TO: Planning Board
FROM: Jeremy Doxsee, Town Planner
DATE: March 4, 2014
RE: Botany Place Condominium Amended Subdivision/Site Plan Approval

Project Name: Botany Place Condominiums
Case Number: 14-007
Tax Map: Map U19, Lot 2
Zoning: Residential 4 Meredith Dr. – West McKeen St. Zoning District
Applicant: Botany Place, LLC, Scott Howard

- Sheet C2 entitled "Condominium Plan Amendment to Phase 7-10", revised 2-21-14.
- Sheet 1 entitled "Master Plan", dated 1--26-13.
- Sheet 2 entitled "Site Plan – Phase 7", revised 2-21-14.
- Sheet 3 entitled "Plan and Profile STA 14+50 To 20+00", revised 1-21-14.
- Sheet 4 entitled "General Notes and Details", revised 1-22-14.
- Sheet 5 entitled "Erosion Control Notes and Details", revised 1-22-14.

FIELD WK: BWM	SCALE: 1" = 100'	SHEET:
DRN BY: RPL	JOB #: 992	C2
CHD BY: KPC	MAP/LOT:	
DATE: 10-26-13	FILE: 992-MASTER PLAN

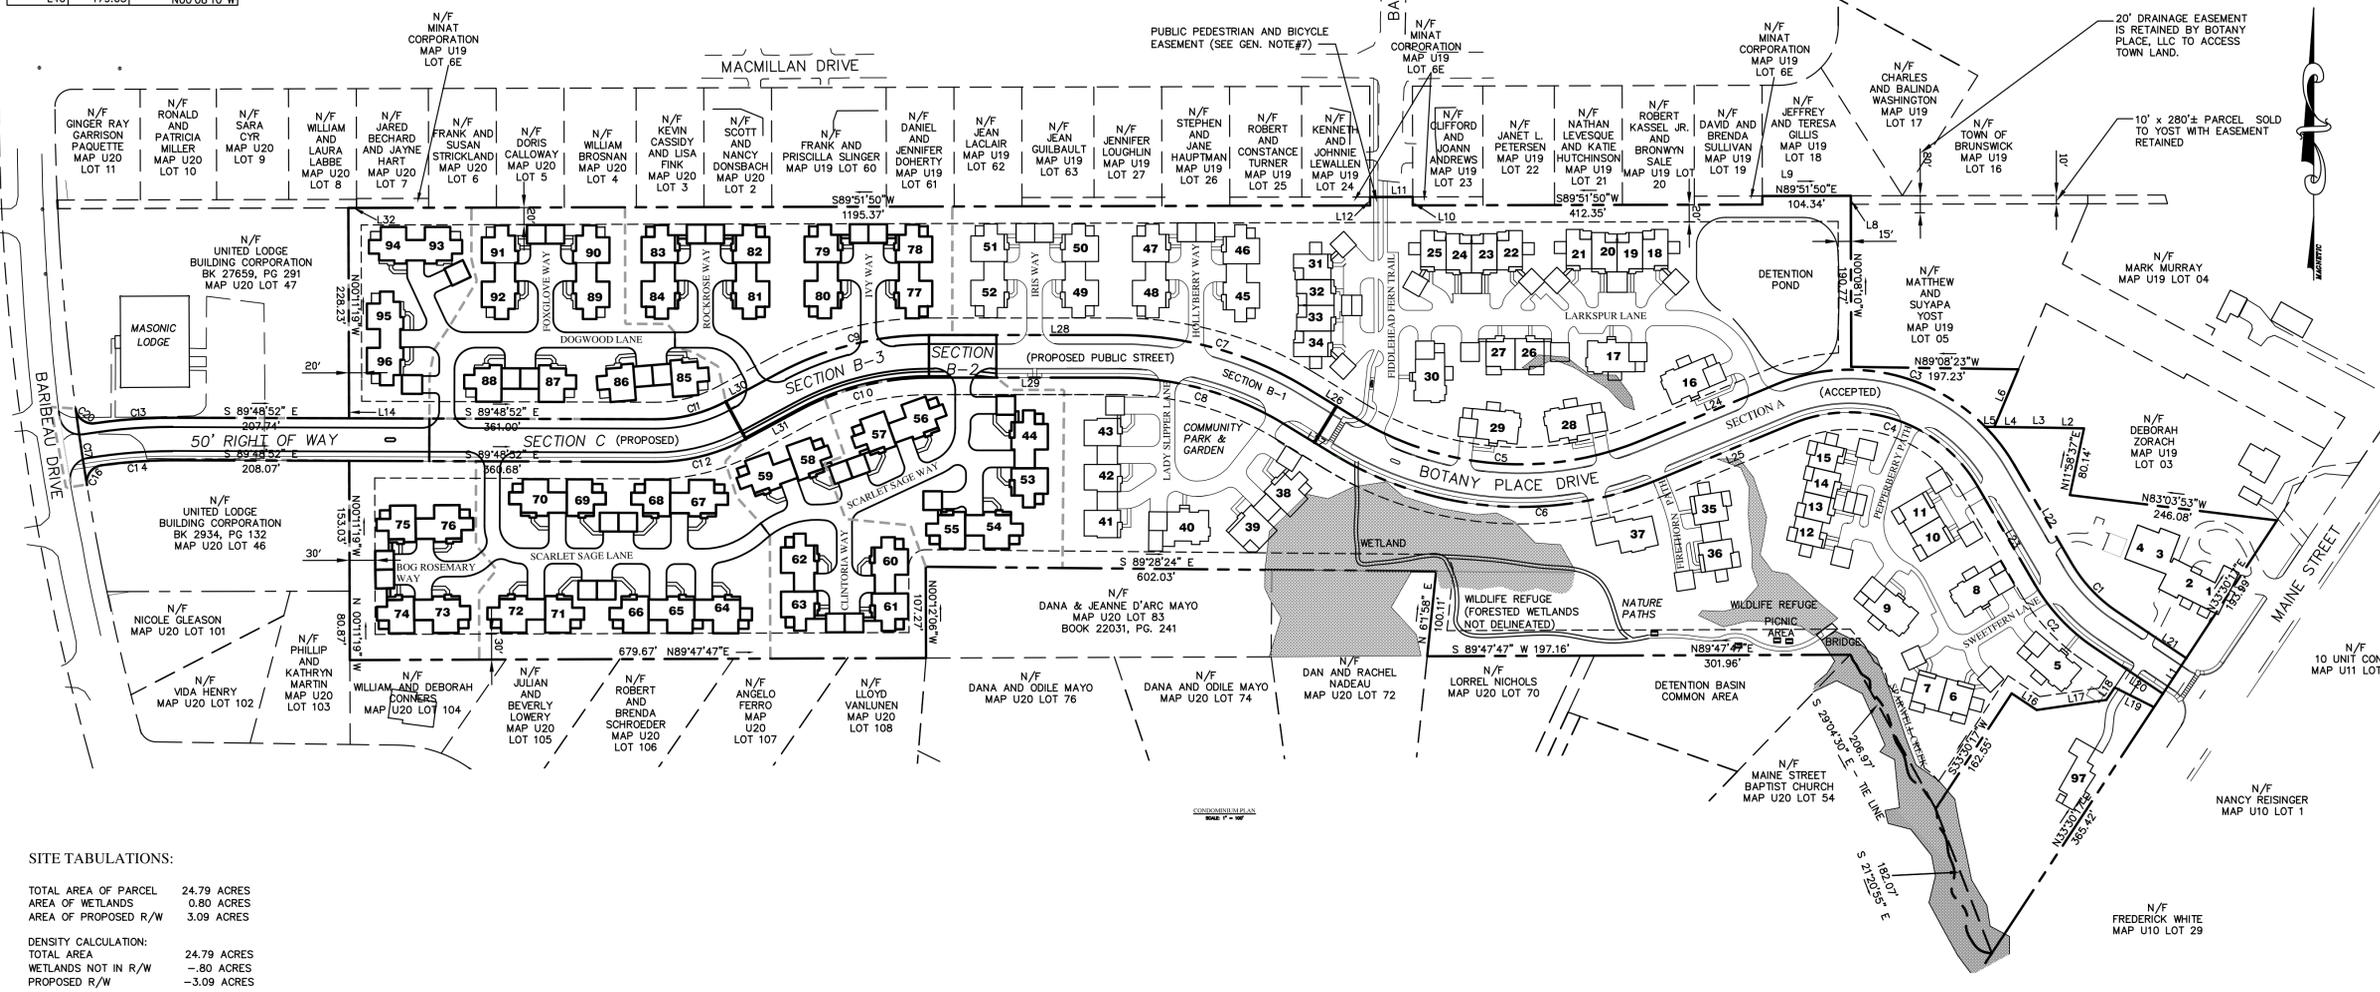
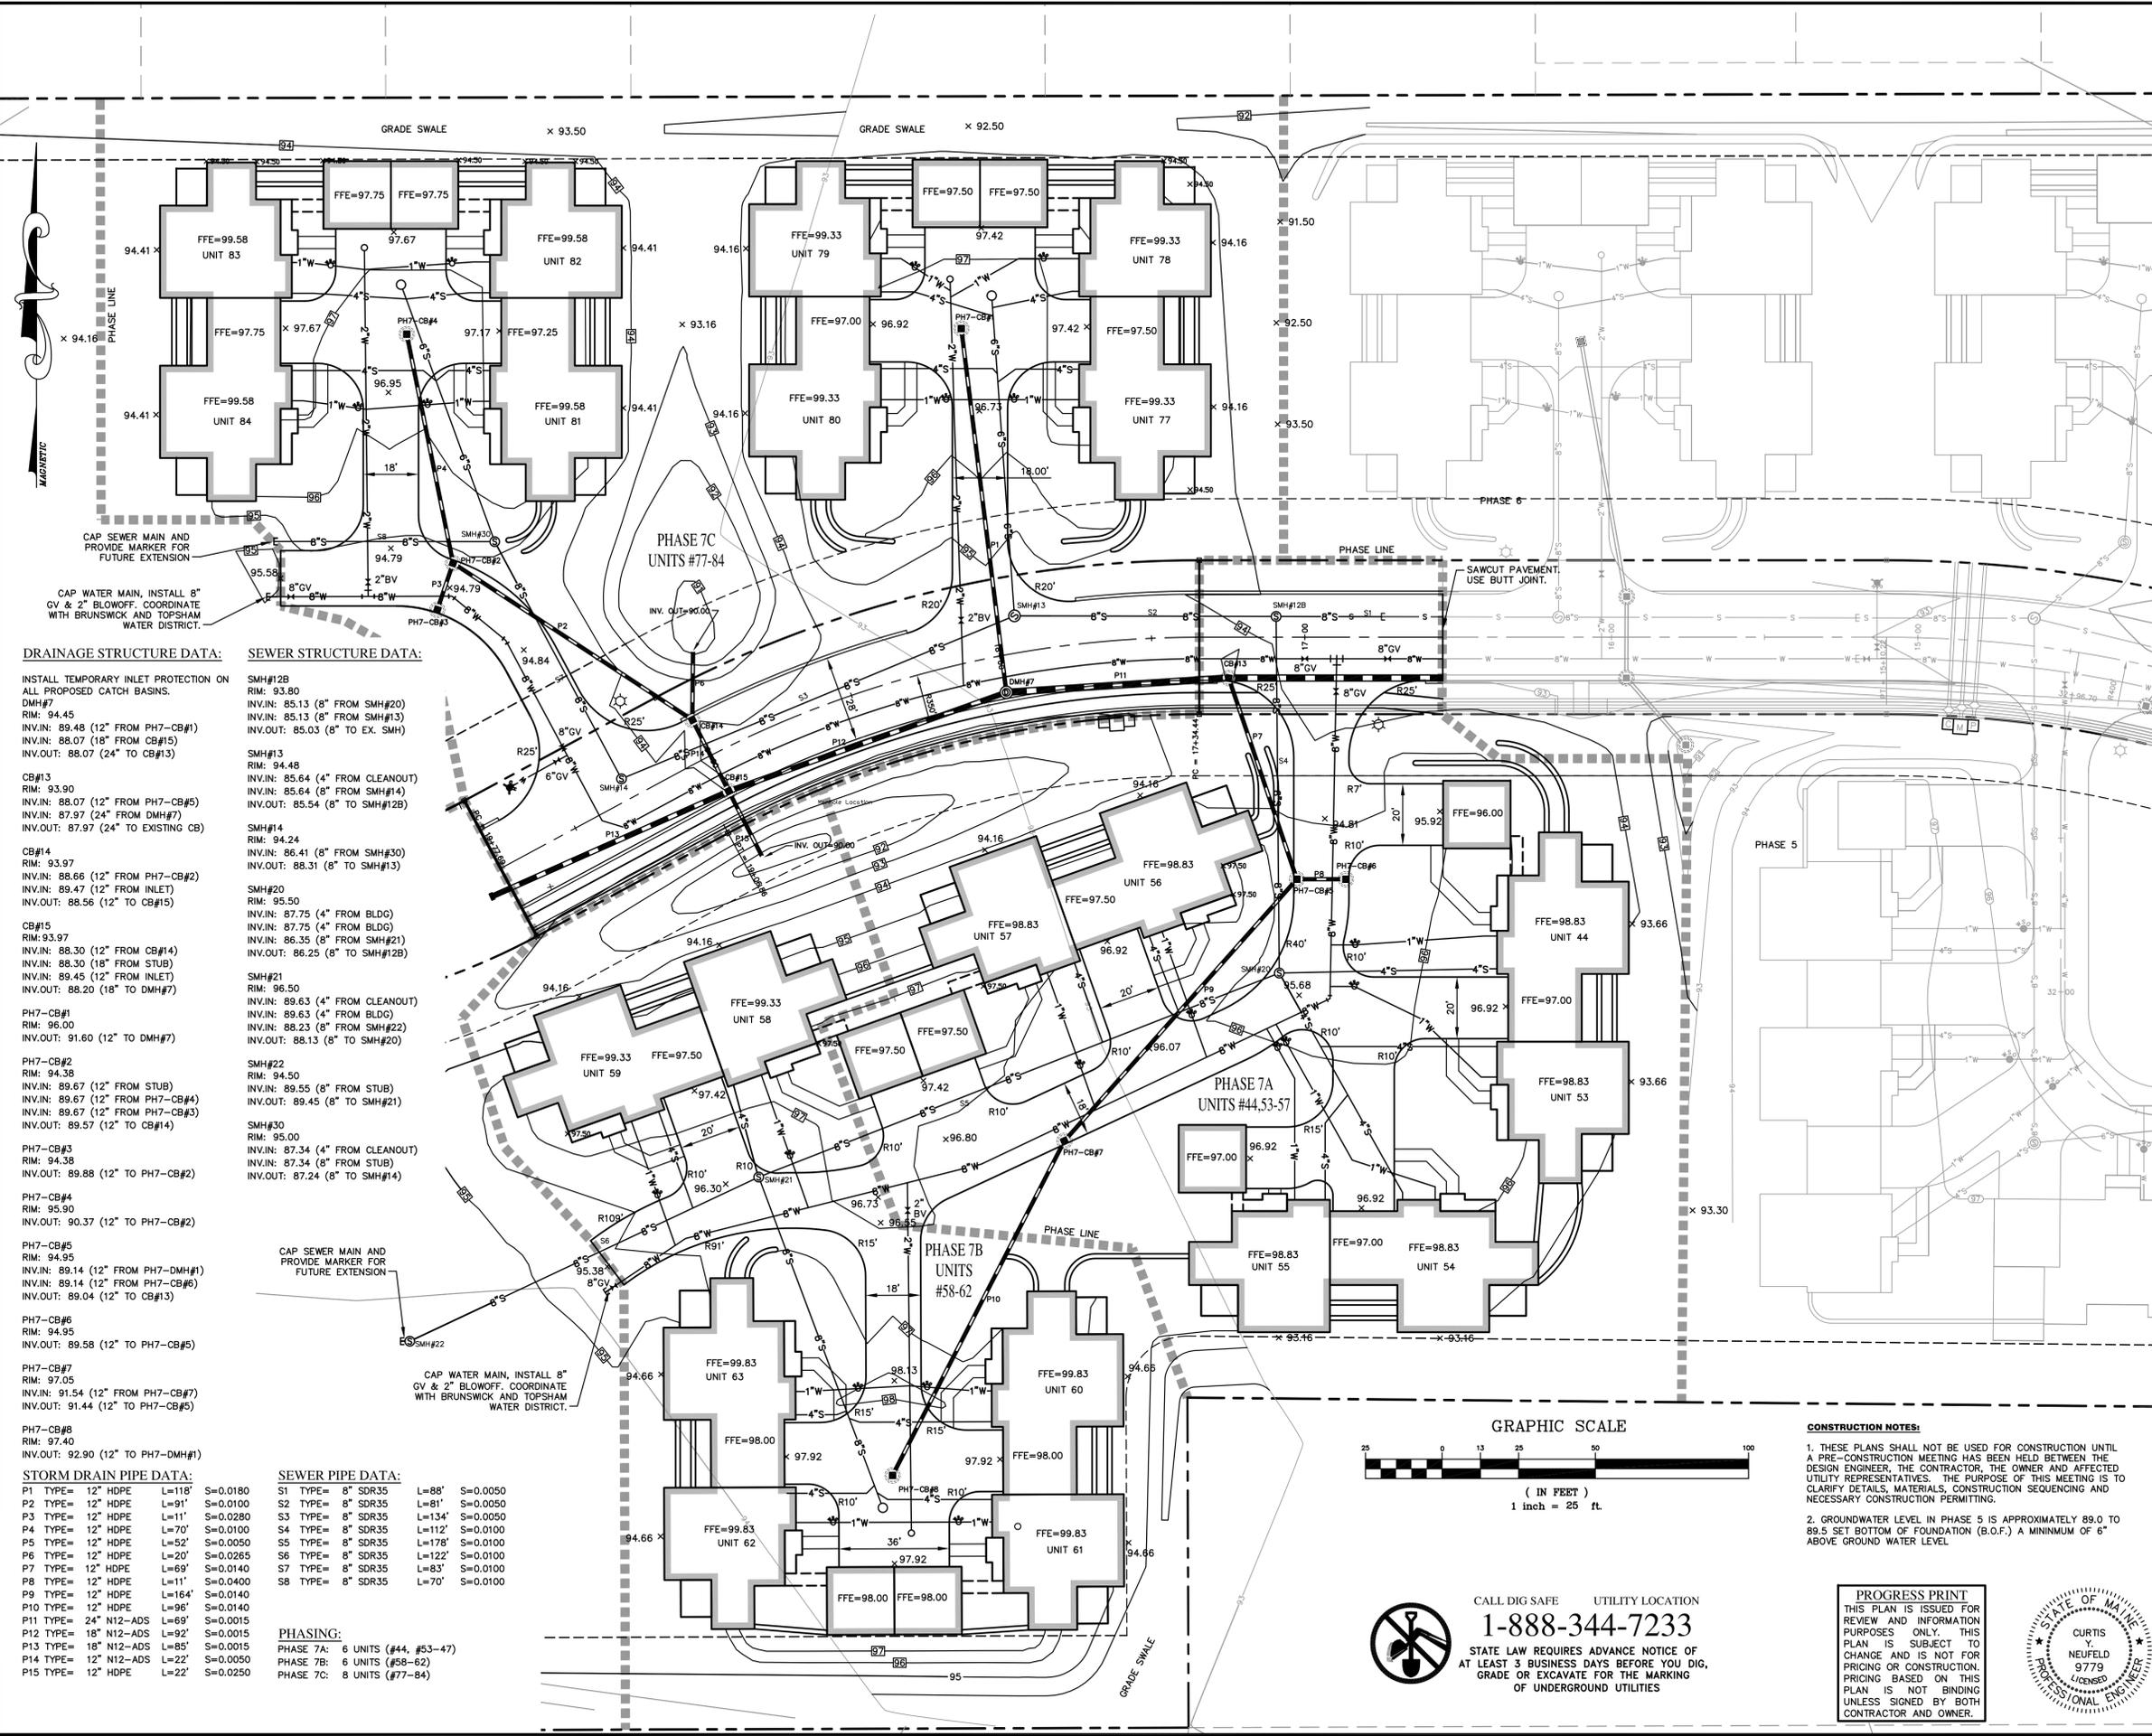
- Label on the plan the area where trails go through wetlands as “forested wetlands”.

- Was involved in public process during original 2003 approval. Elimination of the park and gazebo is not consistent with the original design and master plan.

- The park was to be a benefit to the entire neighborhood, not just the condo association members. The existing flower garden is labeled as community park and garden on the plan, but is really only a flower garden with some lawn areas.

SITE PLAN - PHASE 7
BOTANY PLACE - RESIDENTIAL CONDOMINIUMS
BOTANY PLACE, LLC
CUMBERLAND COUNTY
P.O. BOX 811 - BRUNSWICK, MAINE

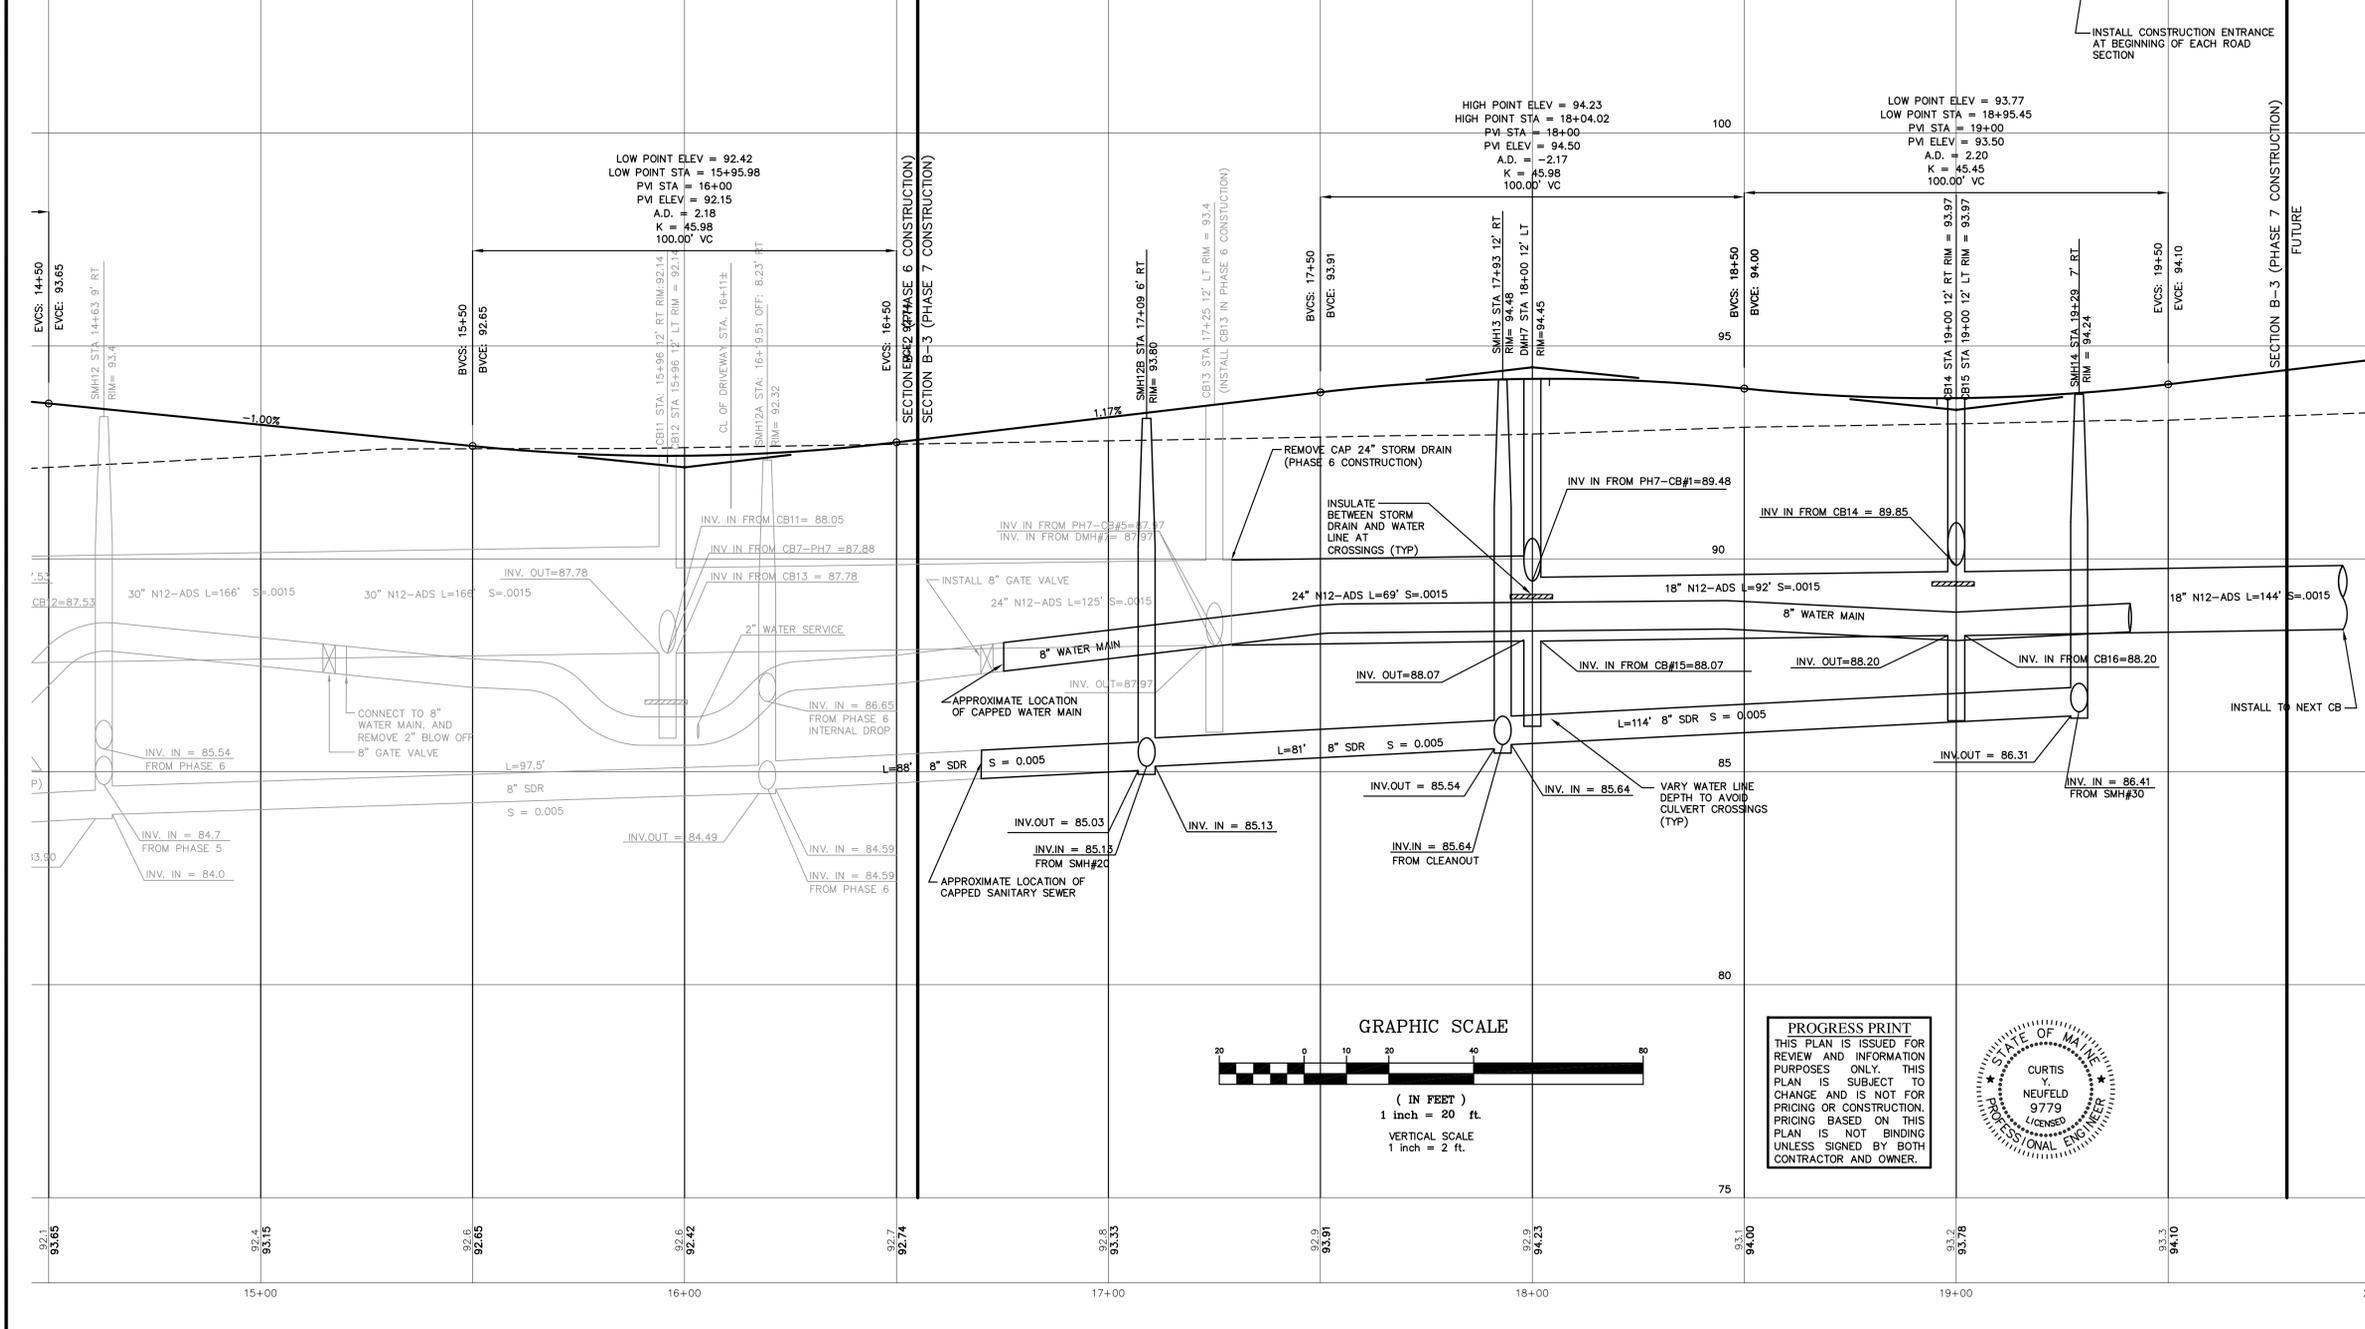
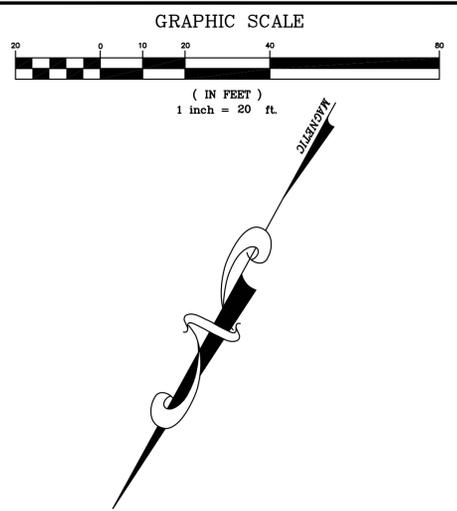
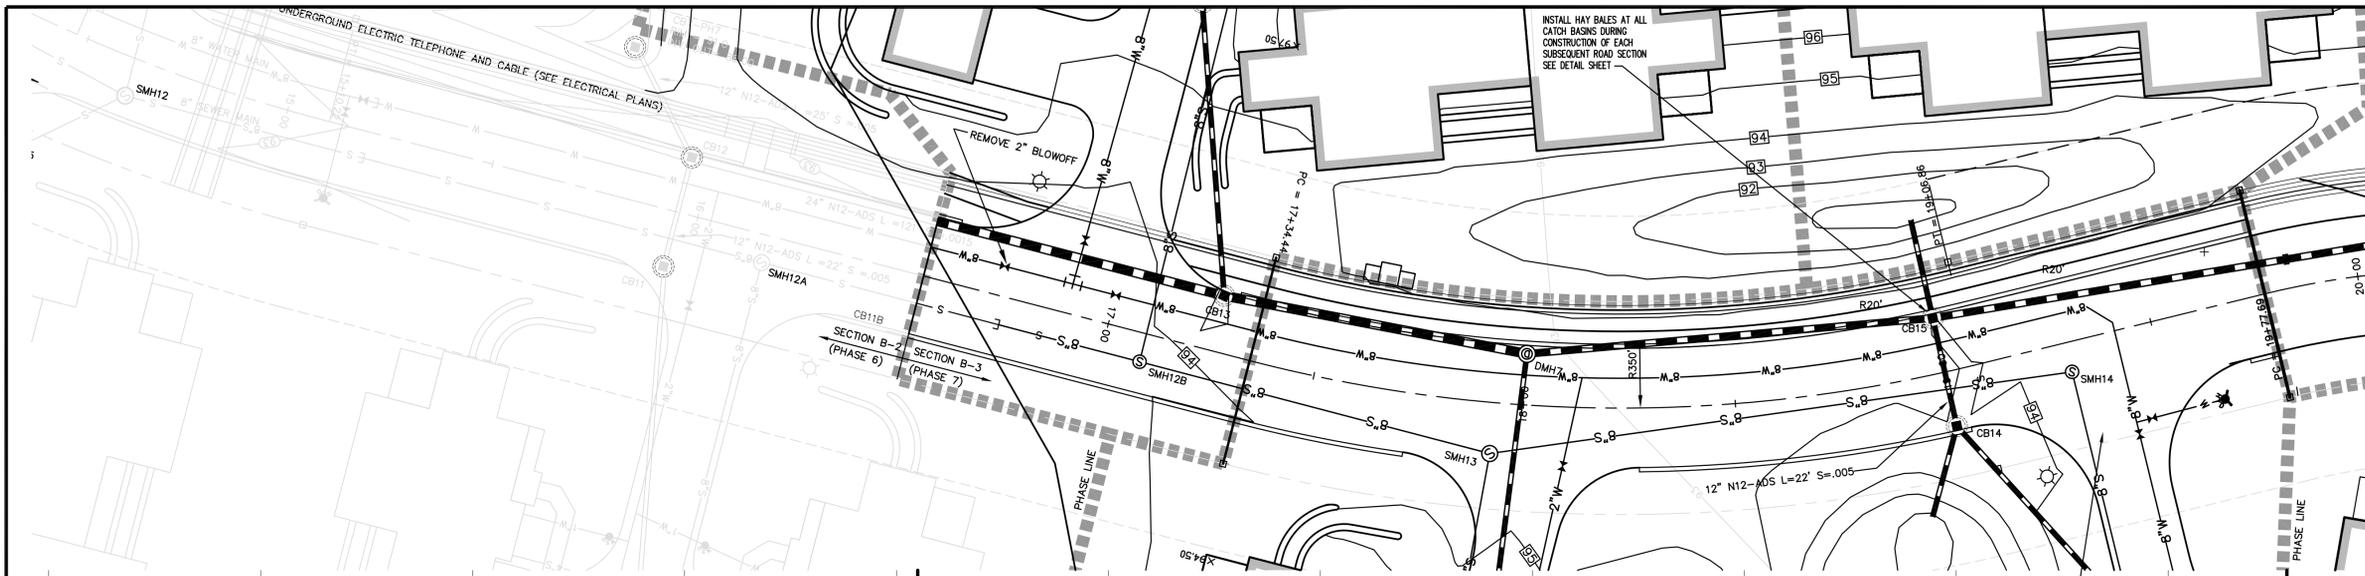
1. The stormwater management system appears to remain in compliance as originally approved but I am concerned about the two proposed "... small ponding areas within Phase 7 ..." Each of the two ponds are drained by a 12 inch culvert that is set at the low point in the pond so there will basically be no ponding or detaining of the runoff. I see the two planned ponds as an ideal opportunity to provide stormwater management for both the quantity and quality of site runoff to the now DEP designated impaired watershed (Mere Brook). I would ask that as a condition of approval the developer have his engineer and landscape architect investigate utilizing these two planned ponds as rain gardens or similar water quality treatment areas. Although a structural flow control structure could be provided in each pond I would prefer the non-structural solution (rain garden) be utilized here.

I would be willing to approve or recommend approval of the stormwater management modification if satisfactory plans for improving the ponds as recommended above are submitted for our approval. Please let me know if you have any questions, thanks, John
